HISTORIC AND DESIGN REVIEW COMMISSION

June 07, 2017

HDRC CASE NO: 2017-273
ADDRESS: 218 COLLEGE ST
LEGAL DESCRIPTION: NCB 416 BLK 23 LOT S PT OF 4 & 5 ARB A-13 (LAND & IMPTS)
RIVERSIDE HOTEL CONDOMINIUM
ZONING: D,HS RIO-3
CITY COUNCIL DIST.: 1
DISTRICT: Alamo Plaza Historic District
LANDMARK: Riverside Hotel
APPLICANT: Daniel Rodriguez
OWNER: Riverside Hotel Condominium Council
TYPE OF WORK: Installation of an entrance awning and street furniture
REQUEST:

Improvements and Awning Reinstallation

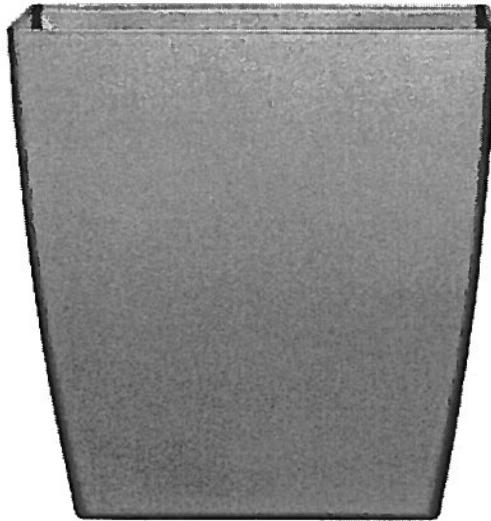
- b. ENTRANCE AWNING – The Guidelines for Exterior Maintenance and Alterations B.ii. notes that the design of new awnings should be based on the architectural style of the building and be proportionate in shape and size to the scale of the building façade. The entrance location for the proposed awning features a decorative door crown and pediment. Significant architectural elements that are original to the historic structure should not be obscured by non-original additions. The applicant has noted a fabric awning to be five (5) feet wide and extend four (4) feet

from the building façade. Staff finds the installation of an entrance canopy to be appropriate; however, the proposed canopy should be fixed to the entrance as to not obscure any of the original architectural elements. Staff finds that the current canopy should protrude from beneath the current Wyndham entrance signage.

- c. ENTRANCE AWNING – The applicant has noted that the proposed awning is to read “218 College Street”, “Wyndham Riverside Suites” and contain the Wyndham logo. The applicant has noted the height of the lettering to be fourteen (14) inches. Staff finds the proposed signage appropriate.
- d. STREET FURNISHINGS – The applicant has proposed to install two planters to flank the entrance as well as a bench to be placed in front of the existing alcove. Staff finds the installation of planters and a bench to be appropriate; however, both should be made of durable materials that are complementary of the architecture of the historic structure.

- i. That the applicant submit an awning detail noting an installation that will not obscure any decorative historic elements for approval by staff prior to the issuance of a Certificate of Appropriateness.
- ii. That the applicant submit product specifics for the proposed planters and bench to staff for approval prior to issuance of a Certificate of Appropriateness.
